# IECC RESIDENTIAL CONSENSUS COMMITTEE RESULTS ON THE 2021 PUBLIC INPUT CHANGES TO THE INTERNATIONAL ENERGY CONSERVATION CODES

This **Committee Action Report (CAR)** includes the following:

Figure 1: Boxplot of SRE of ERVs and HRVs (30-100cfm) from the HVI Certified Products database (Source: TRC 2020 pdf p. 86)

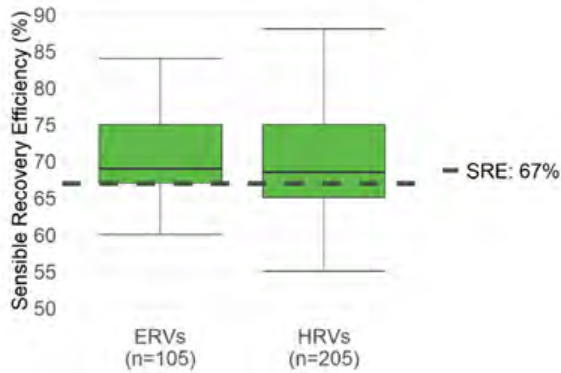
The proposed analysis will assume a higher sensible recovery efficiency (SRE) for the HRV: 67% instead of 65% at 32F (assumed in PNNL 2018). This new assumption is based on typical values for HRVs and ERVs in the Home Ventilating Institute (HVI) database shown in Figure 1, which show that most ERVs and HRVs meet or exceed an SRE of 67%.

Figure 2: Current and Predicted Price of the Avoided Cost of Carbon (Source: E3 2020)

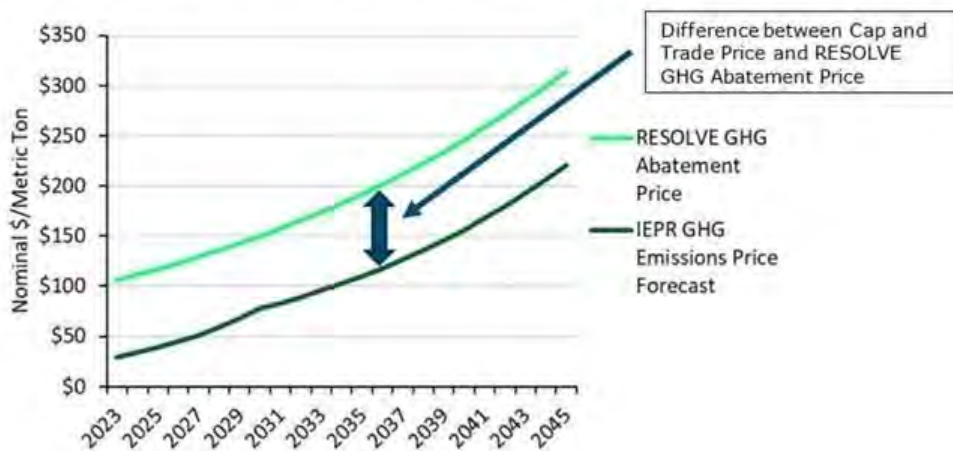
The proposed analysis will include the abated cost of greenhouse gas emissions from reduced energy use. The analysis may use the Integrated Energy Policy Report (IEPR) emissions price forecast, which estimates the current cost of cap-and-trade carbon as \$29 and the societal cost of \$106, or the estimate of \$51 assumed by the U.S. Government Interagency Working Group (2021). The proposal team will follow the latest guidance from the IECC on incorporating the cost of carbon, or the U.S. Government Interagency Working Group (2021) estimate if the IECC is still deliberating on this issue. In addition, the proposal team will assume an increase in the cost of carbon, as demonstrated in Figure 2.

Denver - Average Air Changes  
from Combination of Infiltration and Mechanical Ventilation

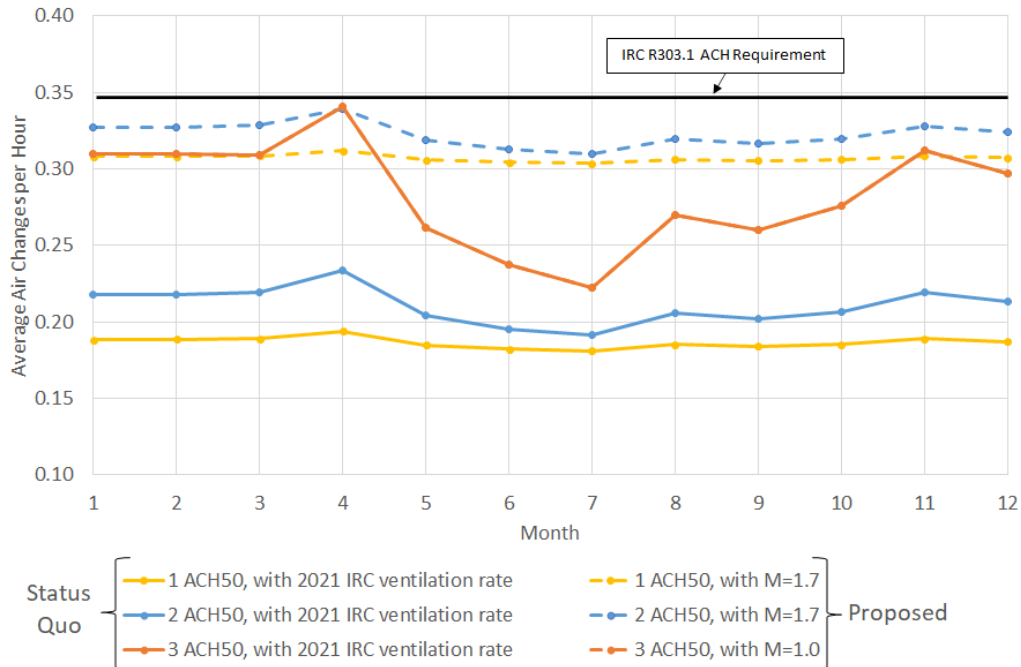
The following graph shows monthly average air changes rates (i.e., total air changes resulting from mechanical ventilation combined with infiltration from building envelope leakage) in Denver, CO for a typical 2200 ft<sup>2</sup> single-family dwelling unit, calculated using the ASHRAE Handbook of Fundamentals.<sup>1</sup> The solid lines show the monthly average air changes resulting from a builder tightening a home without increasing the minimum IRC M1505.4.3 mechanical ventilation rate. At 3.0 ACH50, the home is expected to have an annual average air change rate of 0.28 ACH, which is 20% lower than the 0.35 ACH target. However, if the same home is tightened to 1.0 ACH50 without increasing the mechanical ventilation rate, the annual average air change rate decreases to 0.18 ACH, which is almost 50% lower than the 0.35 ACH target! To incentivize builders to build tight without penalizing them for providing reasonable number of air changes, the performance path's standard reference mechanical ventilation rate should permit higher ventilation rates for very tight construction (i.e., < 3.0 ACH50). In the example chart below, the dashed lines show the maximum air change rate (combined infiltration and mechanical ventilation rate) for the standard reference home that would be permitted by this proposal. These rates are still lower than the traditional 0.35 ACH target and strike a more reasonable balance between health and energy concerns than Table R405.4.2(1)'s current language.

## Mechanical Ventilation as Function of Envelope Tightness

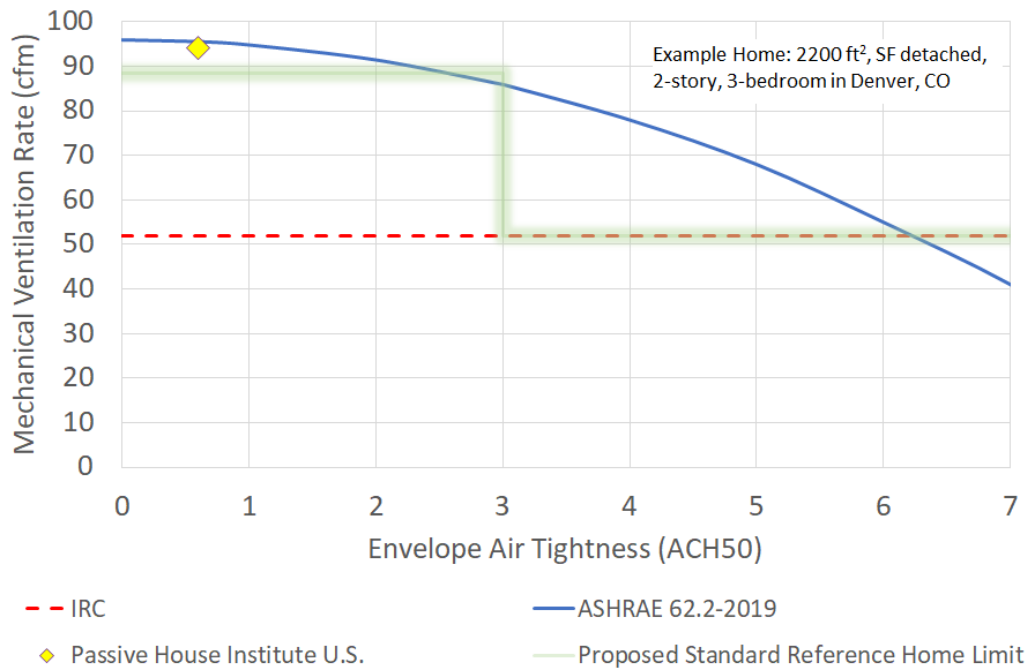
The IRC M1505.4.3 ventilation rate was developed based on the ASHRAE 62.2-2010 ventilation rate equation, which was built around the assumption of the ventilation system being installed in a fairly leaky building that was typical practice at the time (i.e., ~6 - 7 ACH50). In 2012, the IECC required building air sealing to be verified by a blower door test for the first time. In 2013, ASHRAE 62.2 responded to the IECC building air sealing requirements by changing the ventilation rate equation to be a function of the building envelope air tightness level. This change by ASHRAE was intended to provide an occupant with the same amount of fresh air (on an annual basis), regardless of how tightly the occupant's home is constructed. Unfortunately, the IRC M1505.4.3 ventilation rates have not kept pace with improvements in building air sealing. The chart below illustrates how ASHRAE 62.2-2019 rates change as a function of envelope air tightness, which results in comparable fresh air regardless of building tightness. This proposal would permit tight homes (i.e., those with an air tightness below 3 ACH50) to step up their mechanical ventilation rate to a rate comparable to the ASHRAE 62.2-2019 and the IRC R303.1 minimum ventilation rate without penalty.

Figure 1: HVAC Equipment Efficiency at Various Part-Loads

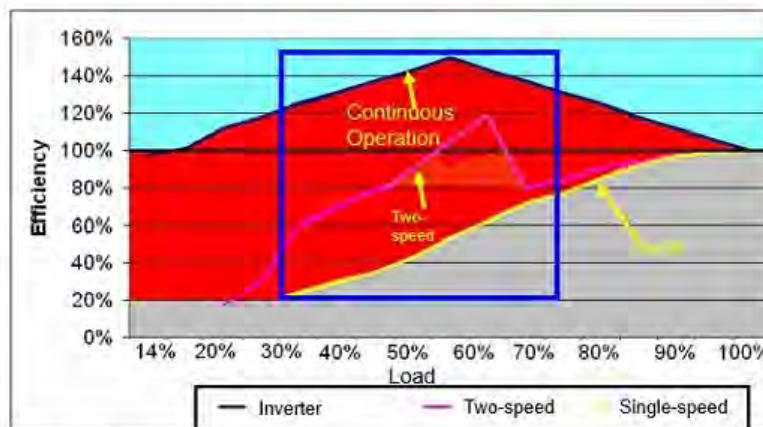
capacities (i.e., less than 100% capacity). When operating at part-load, it can be significantly more efficient. As shown in Figure 1, variable speed equipment's efficiency increases significantly as its load reduces below 100%. This exceeds the performance of both single and two-stage equipment as load reduces. According to computer simulations, validated by the Electric Power Research Institute (EPRI), when variable speed HVAC equipment reduces its cooling capacity by 25% it results in a 43% reduction in power consumption while for single-speed equipment it would yield only a 25% reduction in power consumption<sup>4</sup>. However, according to National Resource Defense Council (NRDC), "current test procedures do not adequately capture the impact of a variable [speed] unit's control logic, which can have a large impact on efficiency<sup>5</sup>." Lastly, Daikin would like to point out that ductless systems can further improve energy performance of HVAC systems by allowing homeowners to turn off indoor units in unoccupied zones.
